Staff Presentation to the ACRS Sub-Committee

**GEH Licensing Topical Report
BWRX-300 Advanced Civil Construction and Design Approach
(NEDO–33914, Revision 1)**

MARCH 18, 2022

Rock Fracture Network

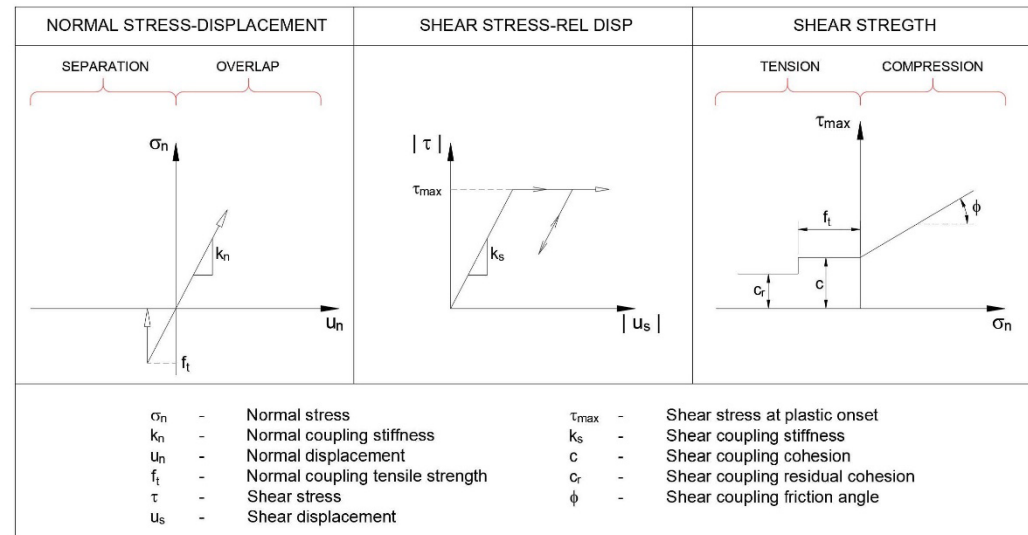
- Fractures control the response of a rock mass
- Fracture network:
 - Dip angle
 - Dip direction
 - Fracture spacing
 - Number of fracture sets
- Staff will review rock fracture network characterization (LTR Section 3) in a site-specific license application

Direct Shear Test of Rock Joint

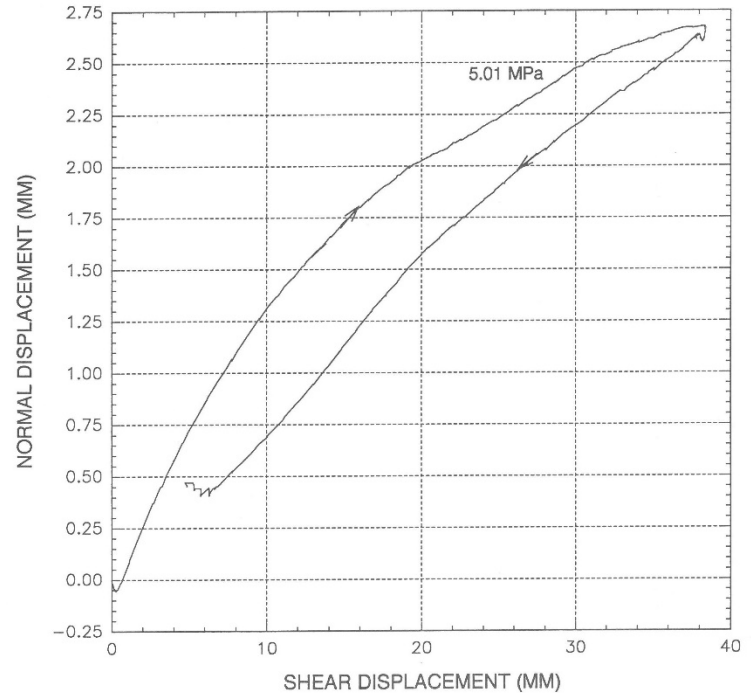
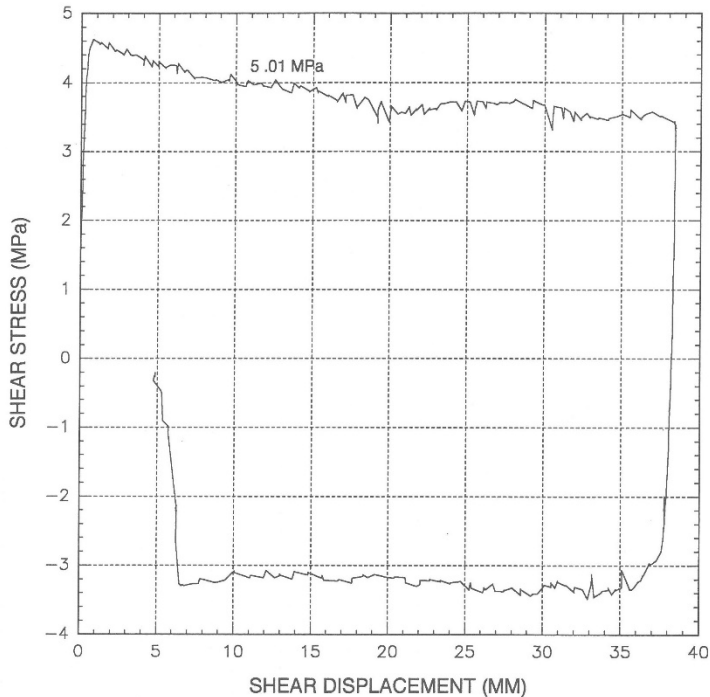
- Large size samples collected at a site should be tested in the laboratory to have an acceptable estimate of the measured fracture (e.g., rock-rock, rock-soil) and interface (e.g., rock/soil-structure) strength and deformation parameters for a nuclear power plant (Response to RAI 02.05.04-2)
- Staff will review the sizes of the samples and their testing at the laboratory to estimate the properties of the discontinuities and interfaces in a site-specific license application with a BWRX-300 SMR

Stability of Reactor Shaft

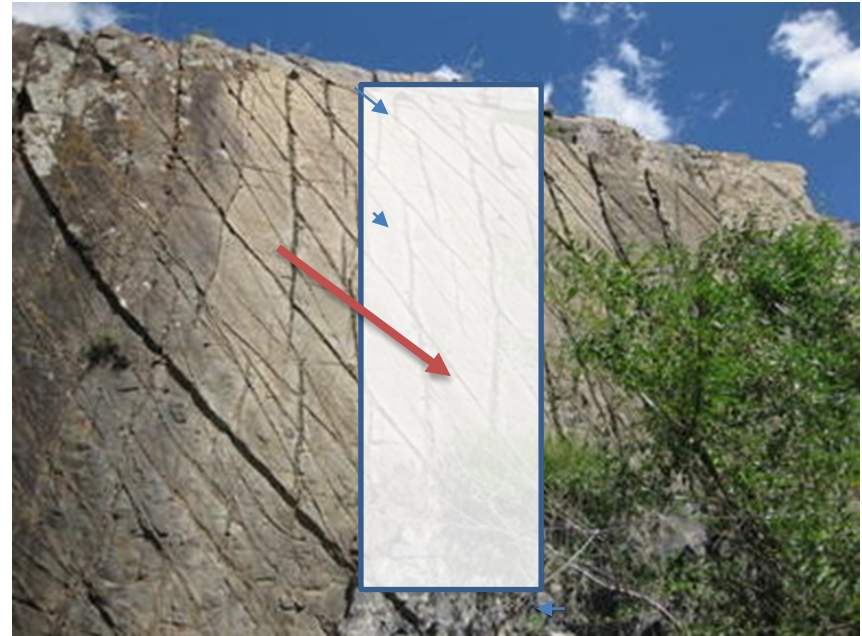
- Stability of Embedded Reactor: Unstable rock mass without any permanent support systems is not acceptable
- Unstable blocks in surrounding region
 - Key block theory (Goodman and Shi, 1985)
 - Numerical simulation e.g., FIA model (LTR Section 4.0)
 - Results verified by instrumentation installed (LTR Section 3.3)

- A stable shaft excavation would have no unstable blocks in its surrounding that may slide into the excavation
- A self-supported (even with some temporary reinforcement) excavation would be needed to place the RB and to estimate the earth pressure loads to be considered in the generic design of the RB structure
- Staff will review method(s) used to identify the unstable rock blocks and to assess the earth pressure imparted on the RB shaft for determining whether the subgrade is acceptable for siting the reactor in a site-specific application
- Any temporary reinforcement or mitigation measures used to stabilize the surrounding materials would be reviewed by the staff
